**City of Sherwood
PLANNING COMMISSION
Sherwood City Hall
22560 SW Pine Street
Sherwood, OR 97140
March 27, 2012 – 7PM**

a. Public Hearing - Sherwood Community Center SP12-01, CUP12-01, VAR 12-01, and VAR12-02
The applicant proposes to remodel the existing 13,050 square foot industrial building into the Sherwood Community Center with commercial tenant space. The project was preliminarily considered as a component of the Sherwood Cannery Square PUD (PUD 09-01). This proposal also includes a request to improve two parking areas with pavement, lighting and landscaping to provide parking for the proposed community center. The properties are zoned PUD-RC and Medium Density Residential High.

Sherwood Community Center

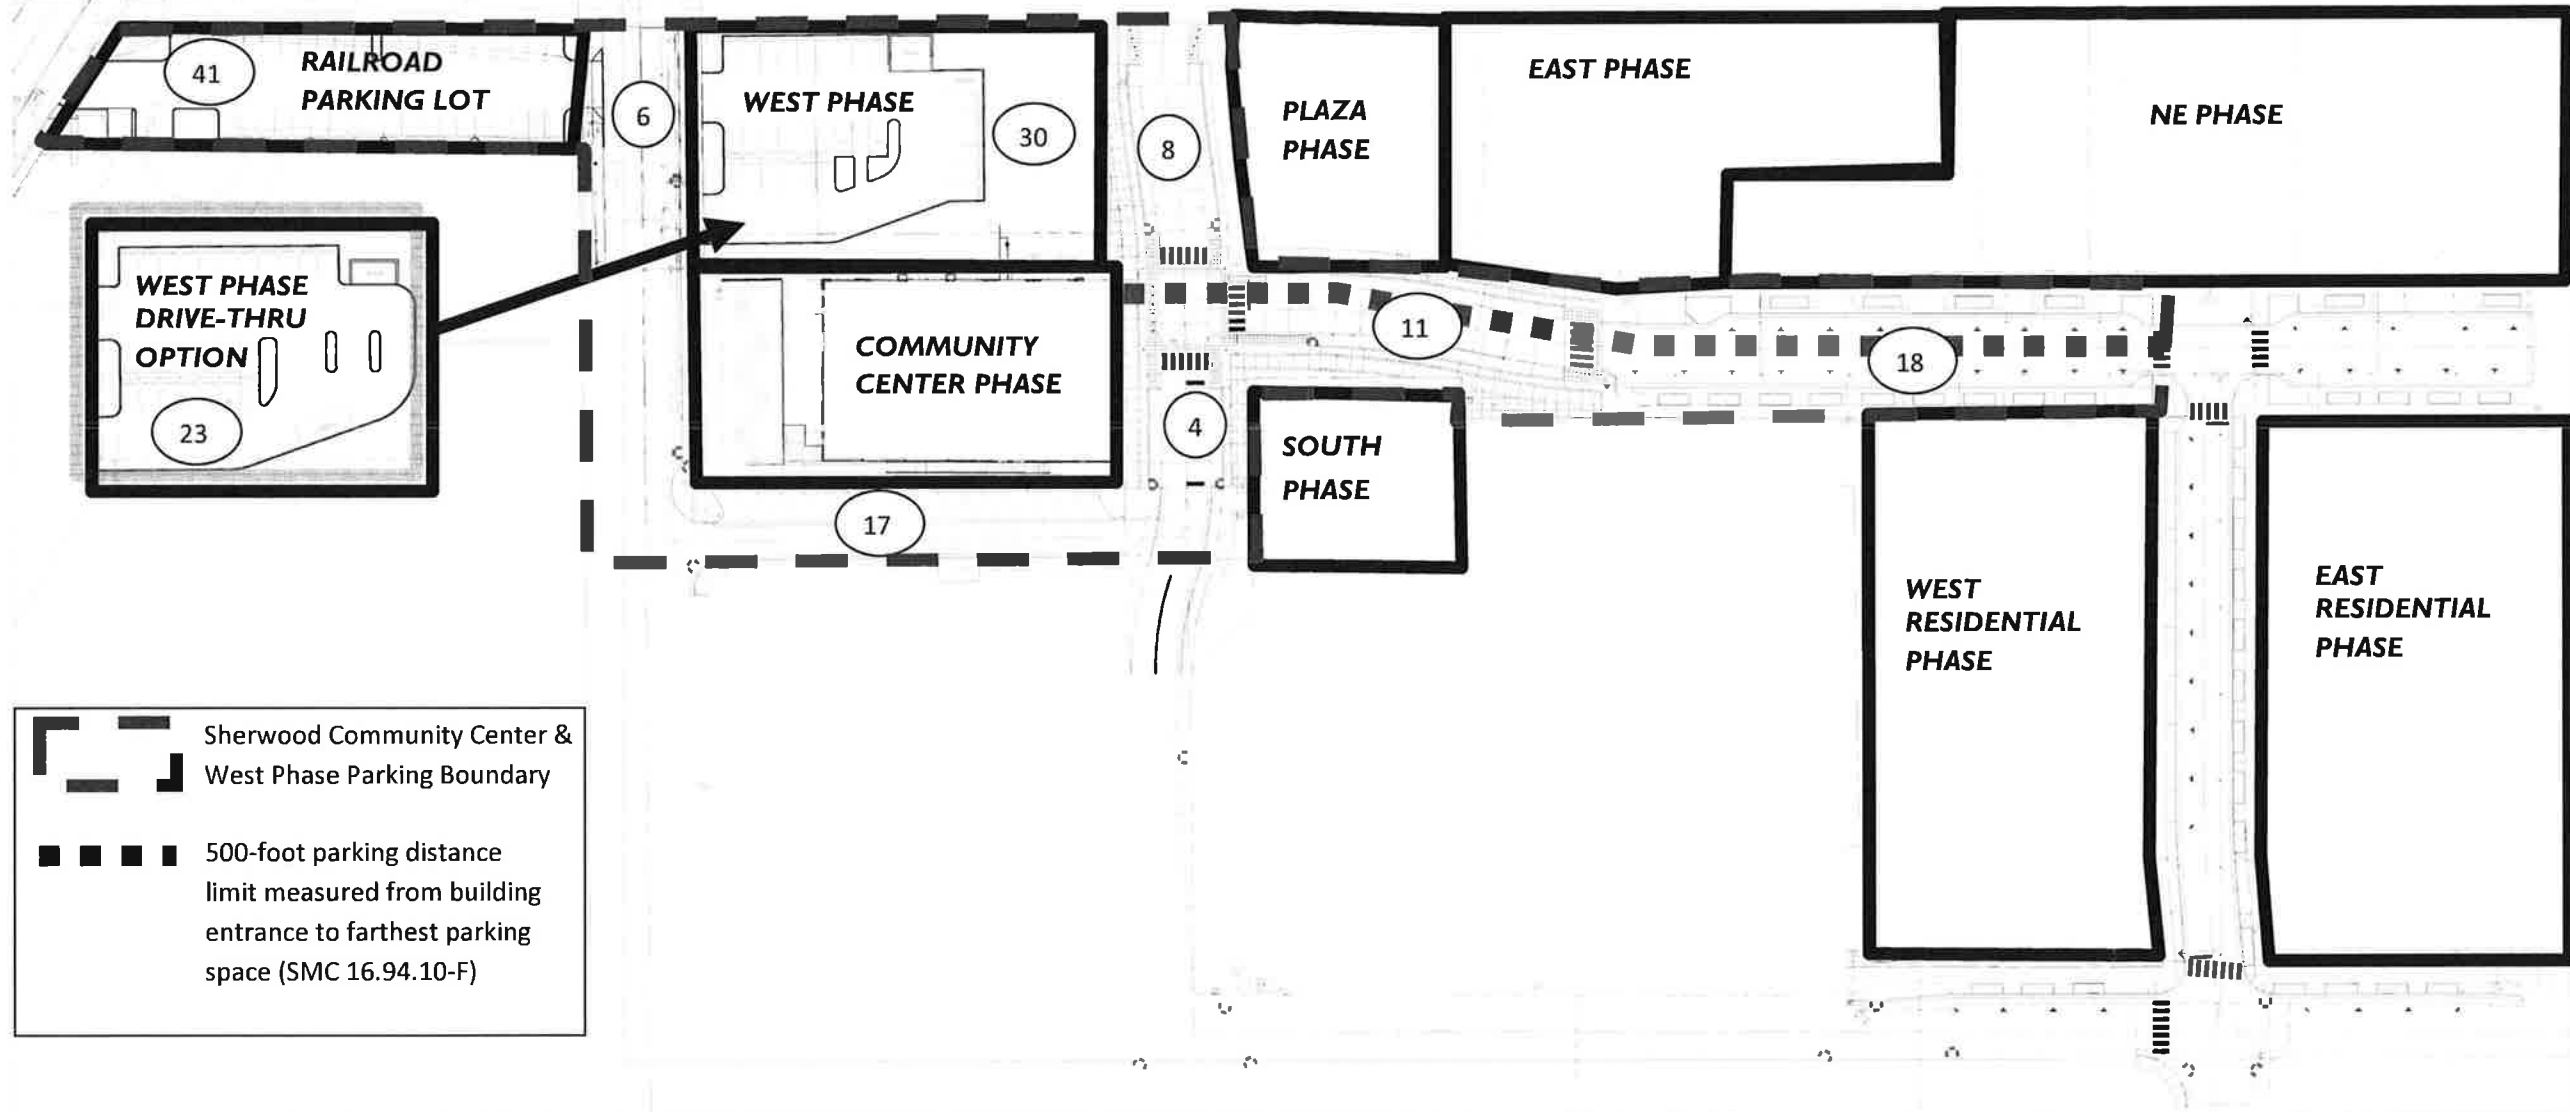
- The inside measurements of the enclosure must be 20' wide and 10' deep.
- No center post at the access point for the gates
- Gates hinged in front of (and not inside) the walls allowing for the full 20' opening
- Gate drop pins to allow the gates to be held in the open position with at least 120 degrees of an opening angle.
 - There is a curb to the Left of the enclosure and a parking space to the Right. The gate to the Left must be able to open the full 120 degrees, so the corner portion of the curb may need to be removed or modified to allow for this. The gate to the Right must be able to open the full 120 degrees also, which means into the parking space to the right of the enclosure.

Typically we ask for 75' of clearance from the opening of the enclosure before any obstructions are met. This site plan shows approximately 30' from the opening of the enclosure to the end of the nearest parking space. The site map does show that the 4 spots directly across from the enclosure do not have curbing between them. This lack of curbing would allow our trucks to pull through these spots in order to access the enclosure (assuming there are no cars parked there at the time we arrive).
